PLANNING AND DEVELOPMENT SERVICES STAFF REPORT

For Planning Commission Meeting of May 20, 2008

**SUBJECT: Bombay Grocers Planned Project Site Plan (3070 Packard Road)
File No. 12112X4.5**

SITE PLAN

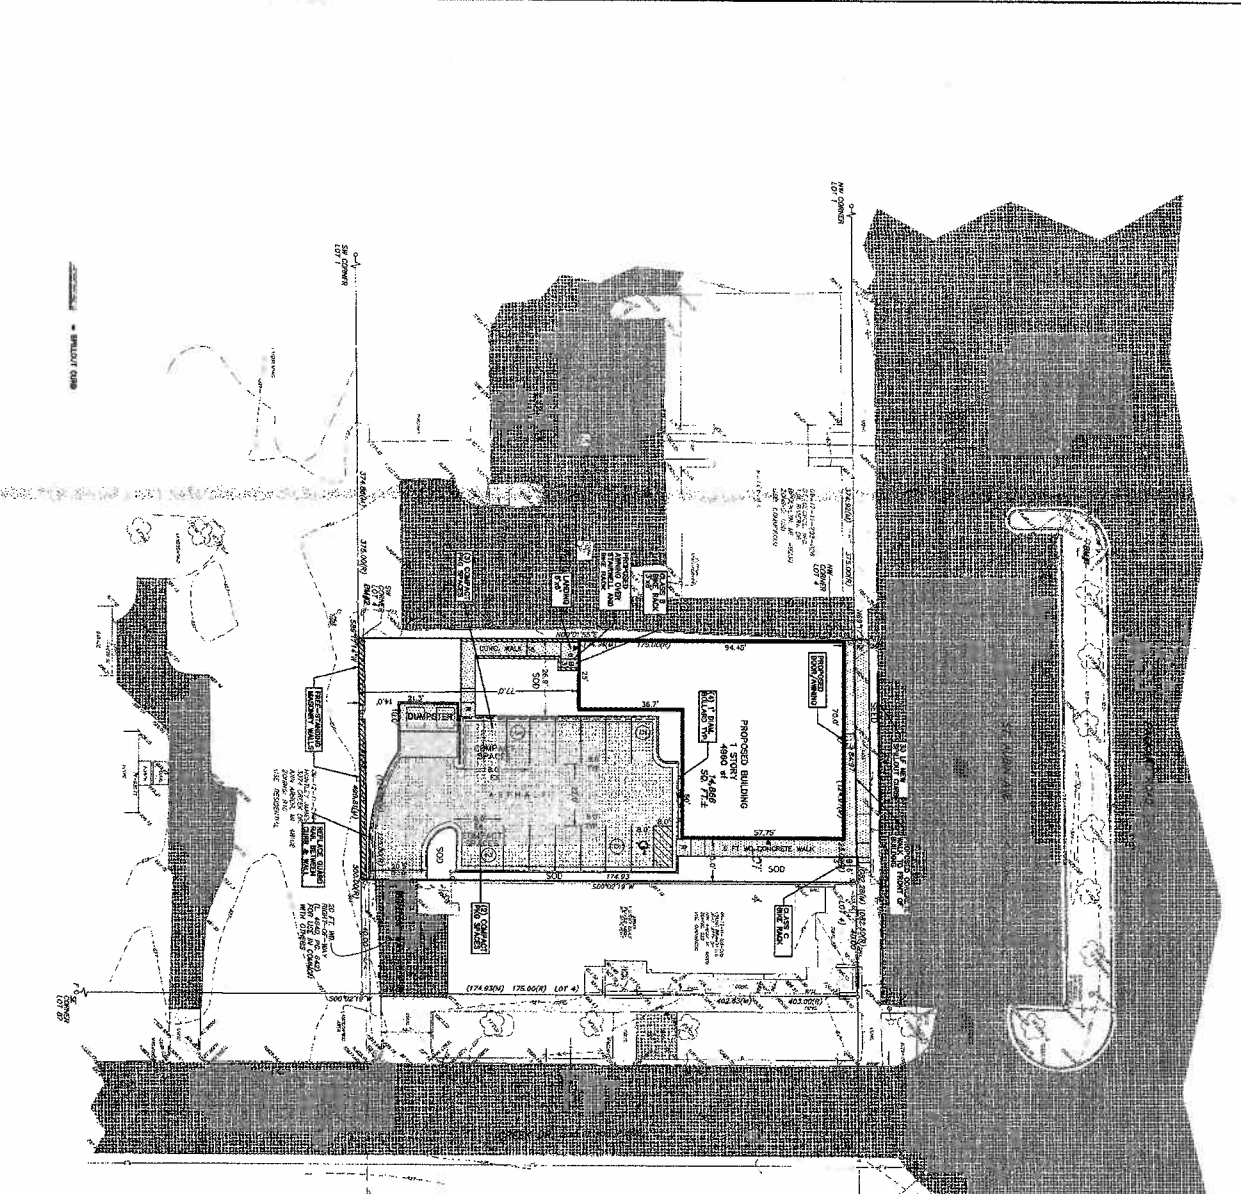
Public Services Area, Systems Planning – The proposed 12-inch storm sewer shall be moved to the north side of the curb. A main line valve is required on the water main to provide separation between the fire service lead to the Fire Department Connection and its supporting fire hydrant.

The dumpster detail does not show a minimum clear opening of ten feet per dumpster, as indicated in the cover letter.

LANDSCAPE PLAN

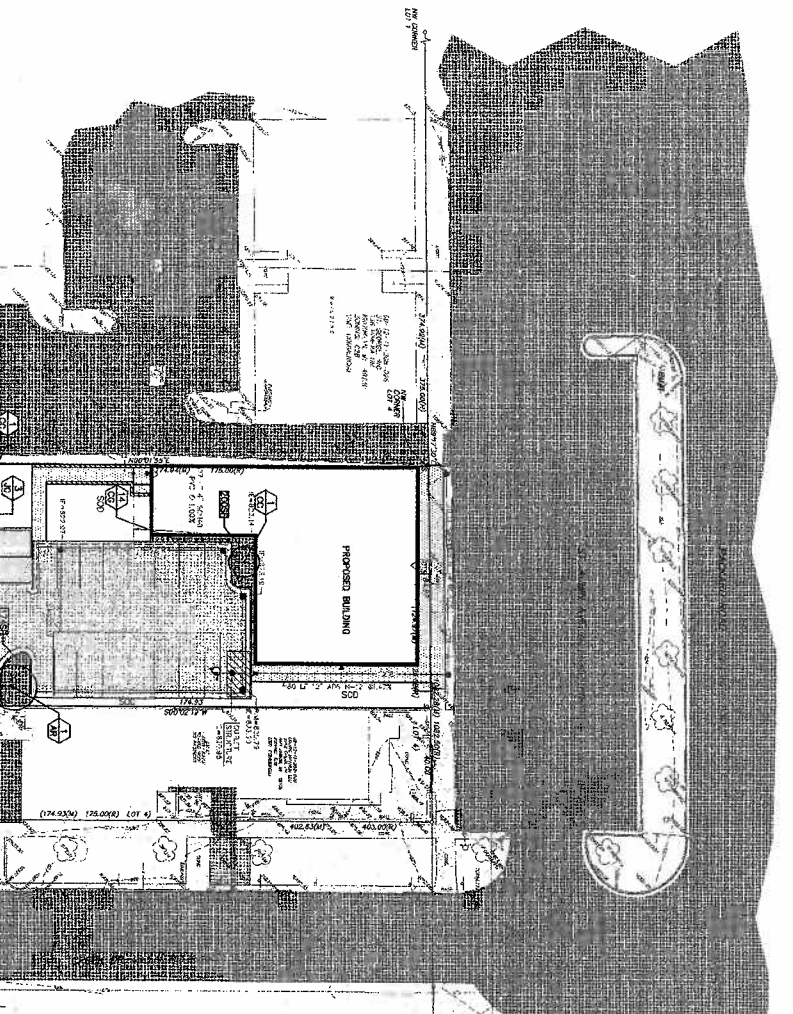
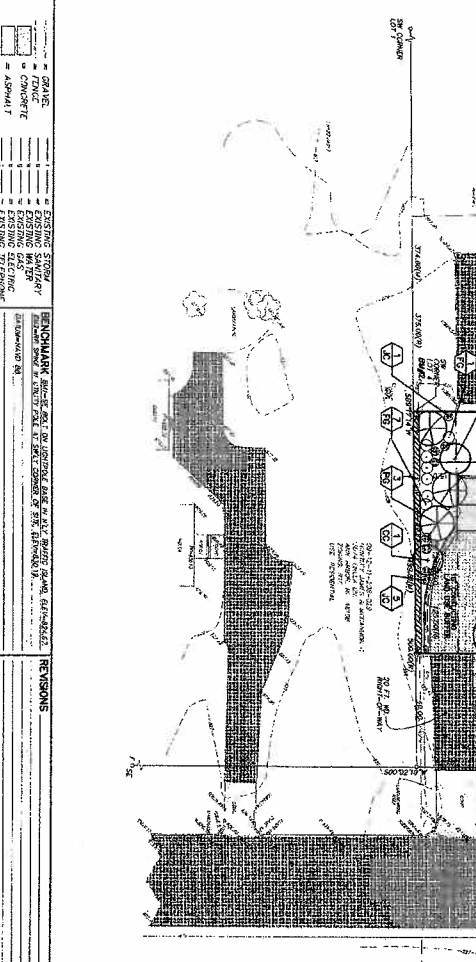
Planning and Development Services (Planning) – The neighbor immediately to the south of the site has requested that the existing six-foot wooden privacy fence along the back of the site remain in place instead of the proposed masonry wall. Existing mature shrubs along the fence on the neighbor's side act as an effective privacy screen and construction of the masonry wall would probably damage or kill the shrubs. The applicant has agreed to use the existing fence instead of the wall shown on the plans.
